SERVICE BULLETIN No.1146A

COACH MODEL	: T2145, S2145 and C2045
BULLETIN TYPE	: Product Improvement
MANUAL & SECTION	: Maintenance Manual: Chapter 4 – Axles, wheels and tires Chapter 7 - Steering Spare Parts Manual: Section 645009 - Wheels Section 642006 – Steering linkage
DATE	: October 22, 2014
SUBJECT	: 9.00 inch wheels
TERMS & CONDITIONS	: No claims will be accepted with reference to this Bulletin.

Figure 1: 8.25 inch vs 9.00 inch wheel tie-rod arms. Note that the casting number is the same (10648246) for all parts. Difference between left hand and right hand parts, and offset is made through stamped markings.

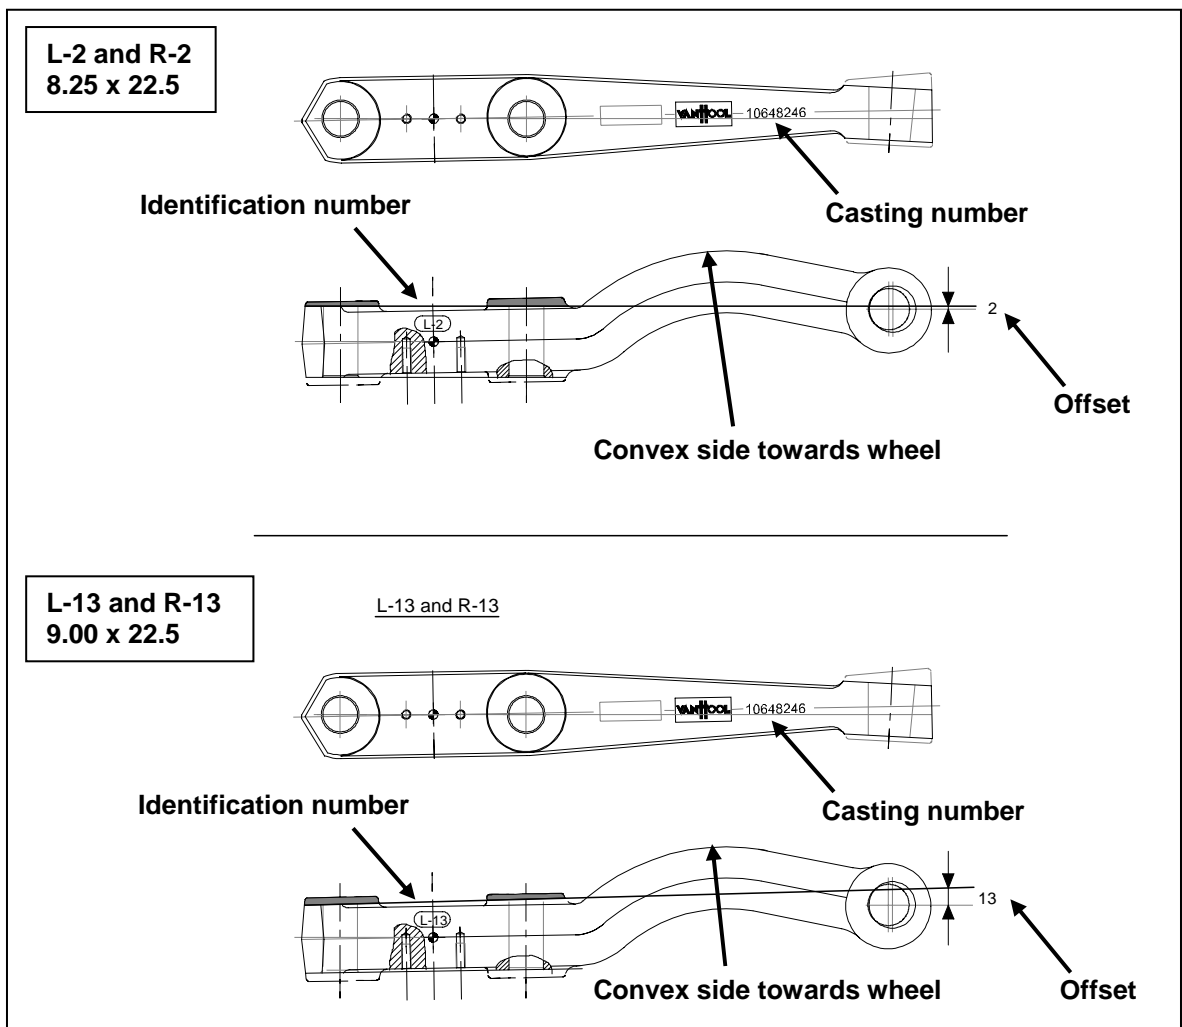
2. 9.00 inch wheels require tie-rod arms with different offset (refer to Figure 1):

- To provide room for the new wheels and to clear the outer tie rod ball joints, different tie-rod arms had to be installed on the front axle.
- All tie-rod arms have the same number (#10648246) cast in them because they originate from the same mold, only to be finished differently (ground at a different angle). Identification has been provided by stamped markings, the key of which is given below.
- When the correct tie-rod arms have been fitted, the clearance between the outer ball joints and the wheel should be approximately 3/8 to 7/16 inch (9.5 to 11 mm).
- As a result of the change, the turning radius of the new production coaches has increased by 19-11/16 inch (500 mm) only.

Key: L-2 = Left-hand, off-set 2mm (5/64 inch); R-2 = Right-hand, off-set 2mm (5/64 inch); L-13 = Left-hand, off-set 13mm (33/64 inch); R-13 = Right-hand, off-set 13mm (33/64 inch).

The convex side of the tie-rod arm should always point towards the wheel.

- The old tie-rod arms **MUST** be replaced by tie-rod arms with a larger offset: 33/64 vs 5/64 inch (13 vs 2 mm), refer to Figure 1. The tie-rod arms must be installed with new screws. Tighten the screws to a torque of 590 ± 60 ft.lbf (800 ± 80 Nm).
 - Secure the outer tie rods to the tie-rod arms as follows:
 - In case of a self-locking nut with nylon insert: use new nuts. Tighten the nuts to a torque of 195 ± 10 ft.lbf (265 ± 15 Nm).
 - In case of a castellated nut: re-use the nuts. Tighten the nuts to a torque of 195 ± 10 ft.lbf (265 ± 15 Nm) and install a new cotter pin.
 - The length of the outer tie rods needs to be changed.
 - The maximum turning angle must be reduced from 57.5° to 55°
 - The steering limiter relief pressure valve should be reset.
 - Alignment must be readjusted.
- *On all three axles:*

Figure 2: Goodyear G391E vs Goodyear Marathon LHS tire characteristics

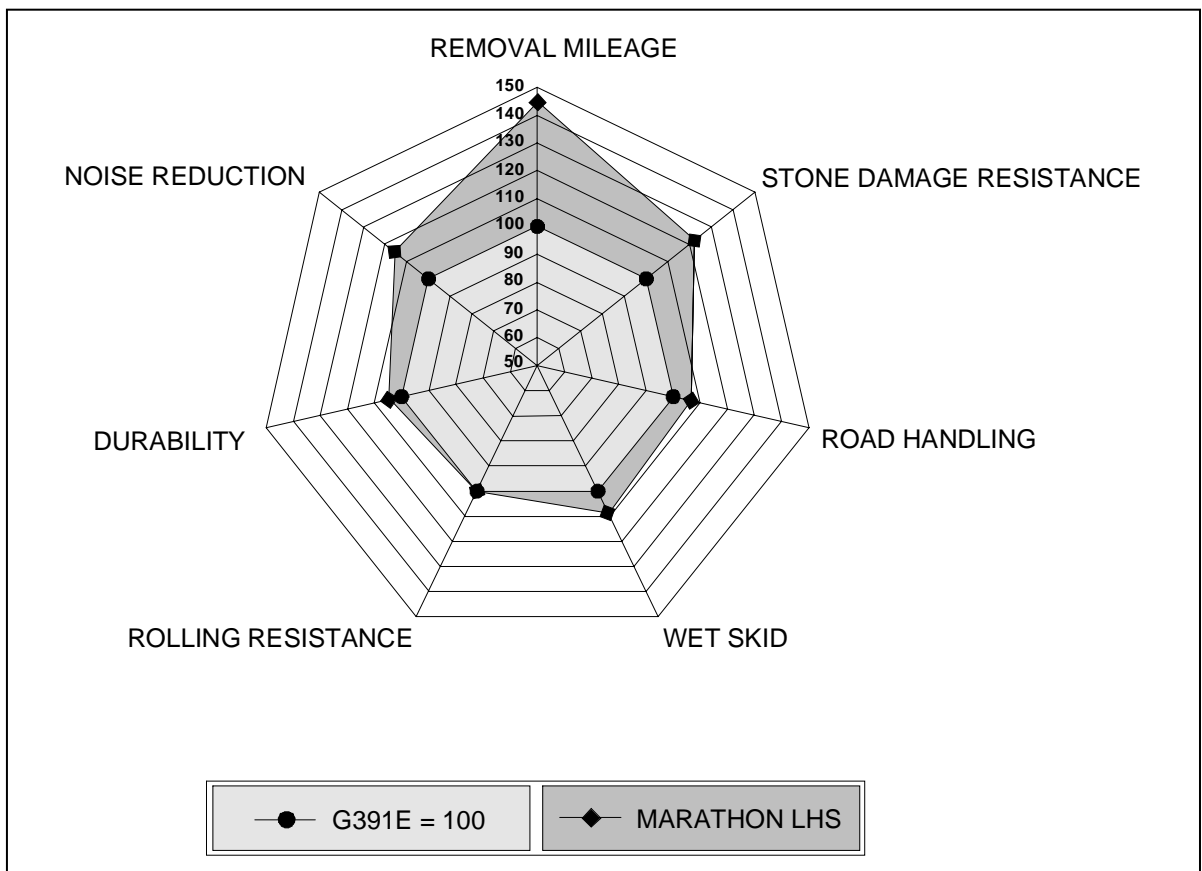
- Touring, Commuter and Shell coaches are factory fitted with Goodyear G391E tires as standard. However, tests at Goodyear have indicated that the Goodyear Marathon LHS tire shows noticeable improvements over the tires currently used on Van Hool coaches.
- As shown in the chart below, the G391E tire characteristics such as removal miles, damage resistance, noise and handling (rated at 100), all have been ameliorated by the Marathon LHS tire (see Figure 2). The LHS tire will therefore replace the G391E tire on new production coaches.
- The old and new tire sizes remaining equal, no changes to the engine parameter settings or speedometer are necessary.
- Other brands of tires may be used, provided they meet or exceed the specifications of the OE items.
